# SUBDIVISION AUTHORITY AGENDA MEETING NO. 42

RE: Tentative plan of subdivision to create one (1) multi-unit housing lot (MHL), from, Lot 11, Block 3A, Plan 152 3973, located north of 101 Avenue NW and east of 67 Street NW; **TERRACE HEIGHTS**

RE: Tentative plan of subdivision to create one (1) additional single detached residential lot from Lot 13, Block 15, Plan 5069 KS, located north of 87 Avenue NW and west of 137 Street NW; PARKVIEW

RE: Tentative plan of subdivision to create one (1) additional single detached residential lot from Lot 1, Block 120, Plan 4590 W and the easterly 3.05 metres of Lot 2, Block 120, Plan 4590 W, located south of 101 Avenue NW and west of 143 Street. **GROVENOR**

# TENTATIVE PLAN

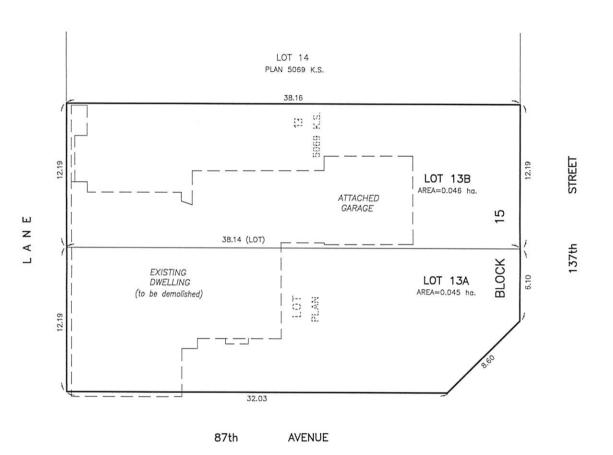
- Access for future development must be to the adjacent alley in conformance with Mature Neighbourhood Overlay Section 814.3(17) of the Zoning Bylaw #12800.
- There is an existing access to 87 Avenue NW and 137 Street NW. Upon redevelopment of proposed Lot 13A, the existing residential access to 87 Avenue NW and 137 Street NW must be removed. The owner/applicant will be required to obtain a Permit to remove the access, available from Development and Zoning Services, 2nd Floor, 10111 - 104 Avenue NW, Edmonton.

- The existing services (water, sanitary and storm) enter the proposed subdivision approximately 12.5 m north of the south property line of Lot 13 off of the lane. As per the EPCOR Drainage Services Bylaw and the EPCOR Water Services and Wastewater Treatment Bylaw, these services cannot cross the proposed property line.

- that the owner apply for a permit to demolish the existing dwelling and garage prior to endorsement of the final plan. Demolition permits can be obtained from Development Services located on the 2nd floor of Edmonton Tower at 10111 - 104 Avenue NW; and
- 2. that the owner pay all outstanding property taxes prior to the endorsement of the plan of survey.

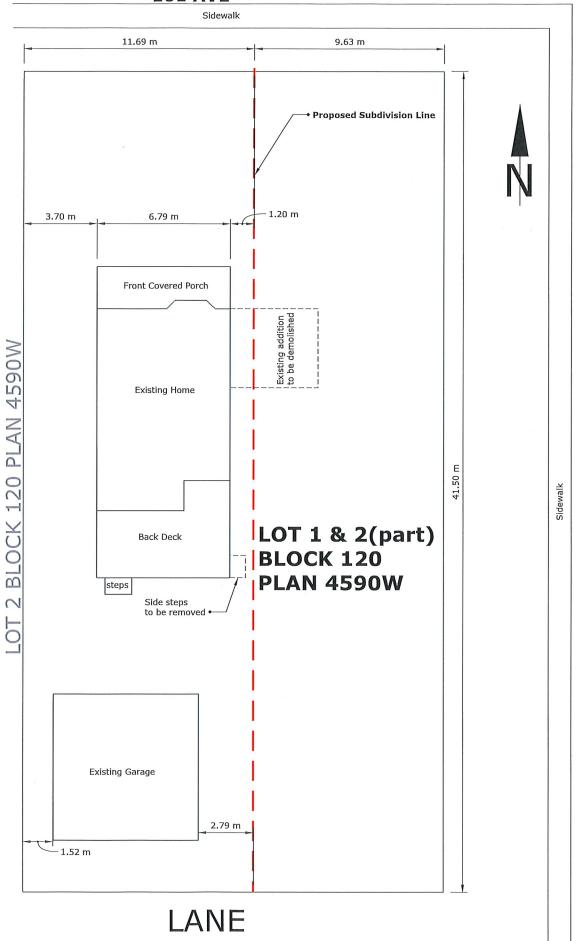
- There are existing boulevard trees adjacent to the site on 101 Avenue NW and 143 Street NW
  that must be protected during construction. For information about tree protection please refer
  to the City of Edmonton's website (Trees and Construction).
- Access for future development must be to the adjacent alley in conformance with Mature Neighbourhood Overlay Section 814.3(17) of the Zoning Bylaw #12800.

- The existing services (water and sanitary) enter the proposed subdivision approximately 18.9 m east of the west property line of Lot 1 off of the lane. The existing storm service enters the proposed subdivision approximately 1.52 m west of the east property line of Lot 2 off of the lane. As per the EPCOR Drainage Services Bylaw and the EPCOR Water Services and Wastewater Treatment Bylaw, these services cannot cross the proposed property line.

- 1. that the owner apply for a permit to demolish the existing "addition to be demolished" prior to endorsement of the final plan. Demolition permits can be obtained from Development Services located on the 2nd floor of Edmonton Tower at 10111 104 Avenue NW;
- 2. that the owner pay all outstanding property taxes prior to the endorsement of the plan of survey.

# TENTATIVE PLAN

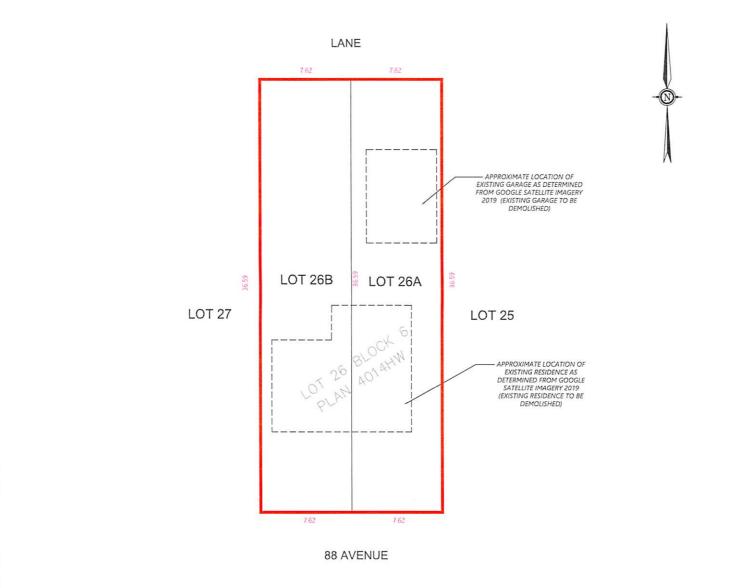
- Access for future development must be to the adjacent alley in conformance with Mature Neighbourhood Overlay Section 814.3(17) of the Zoning Bylaw #12800.
- There is an existing concrete pad with fencing that encroaches onto the 88 Avenue road right-of-way that must be removed with future redevelopment of the site. Permanent objects are not permitted to encroach within road right-of-way without entering into an Encroachment Agreement with the City of Edmonton. Email encroachmentagreements@edmonton.ca for information on Encroachment Agreements.

- The existing services (water and sanitary) enter the proposed subdivision approximately 7.1 m east of the west property line of Lot 26 off of the lane. As per the EPCOR Drainage Services Bylaw and the EPCOR Water Services and Wastewater Treatment Bylaw, these services cannot cross the proposed property line.

- There is a deficiency in on-street hydrant spacing adjacent to the property. The applicant/owner is advised to review on-site fire protection requirements to ensure adequate coverage (contact EPCOR Water at 780-412-3955).

- that the owner apply for a permit to demolish the existing dwelling and garage prior to endorsement of the final plan. Demolition permits can be obtained from Development Services located on the 2nd floor of Edmonton Tower at 10111 - 104 Avenue NW; and
- 2. that the owner pay all outstanding property taxes prior to the endorsement of the plan of survey.

# TENTATIVE PLAN

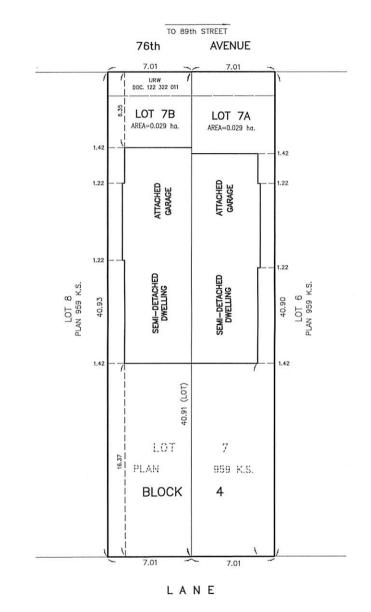
- The existing services (water and sanitary) enter the proposed subdivision approximately 2.0 m west of the east property line of Lot 7 off 76 Avenue NW. As per the EPCOR Drainage Services Bylaw and the EPCOR Water Services and Wastewater Treatment Bylaw, these services cannot cross the proposed property line.

- that the owner enter into a Servicing Agreement with the City of Edmonton for the payment of the applicable Permanent Area Contributions, pursuant to Section 655 of the Municipal Government Act (contact Development.Coordination@edmonton.ca);
- that the owner make satisfactory arrangements with EPCOR Water Services Inc. and EPCOR
   Drainage Services for the provision of separate services (water and sanitary) to the proposed
   western lot; and
- 3. that the owner pay all outstanding property taxes prior to the endorsement of the plan of survey.

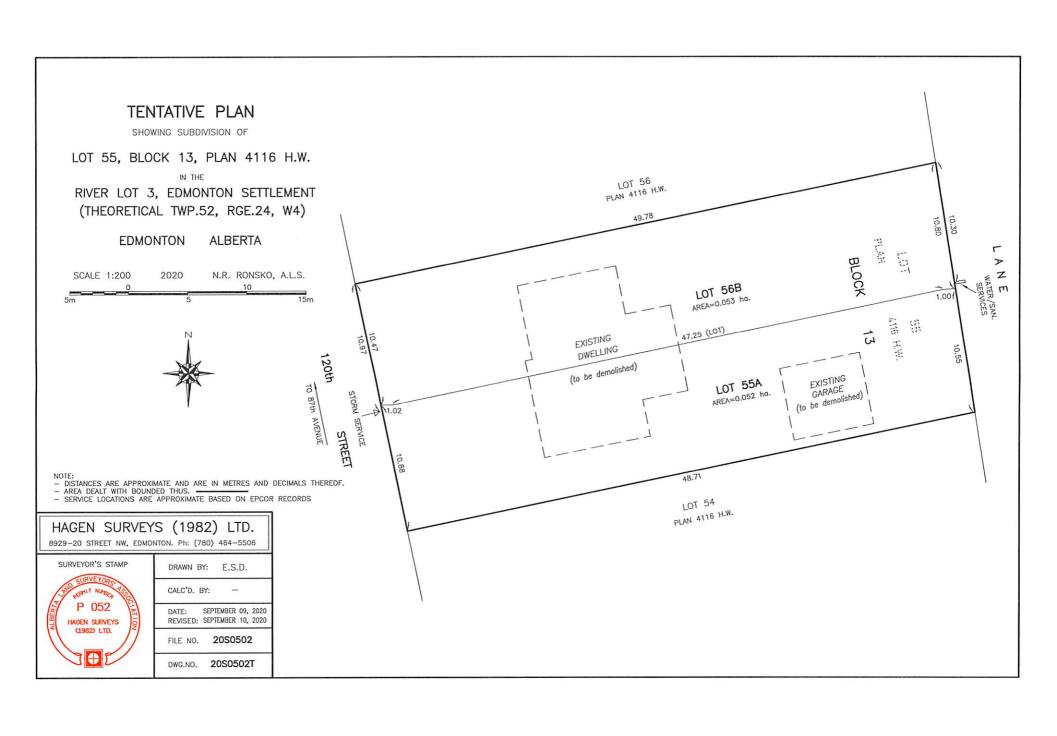
- There are existing boulevard trees adjacent to the site on 120 Street NW that must be protected during construction. For information about tree protection please refer to the City of Edmonton's website (Trees and Construction).
- Access for future development must be to the adjacent alley in conformance with Mature Neighbourhood Overlay Section 814.3(17) of the Zoning Bylaw #12800.
- There is an existing power pole located in the lane. Site access must maintain a minimum clearance of 1 m from the closest edge of the power pole to the closest edge of the proposed driveway.

- The existing services (water and sanitary) enter the proposed subdivision approximately 10.3 m south of the north property line of Lot 55 off of the lane. The existing storm service enters the proposed subdivision approximately 10.97 m south of the north property line of Lot 55 off 120 Street. As per the EPCOR Drainage Services Bylaw and the EPCOR Water Services and Wastewater Treatment Bylaw, these services cannot cross the proposed property line.

- There is a deficiency in on-street hydrant spacing adjacent to the property. The applicant/owner
  is advised to review on-site fire protection requirements to ensure adequate coverage (contact
  EPCOR Water at 780-412-3955).
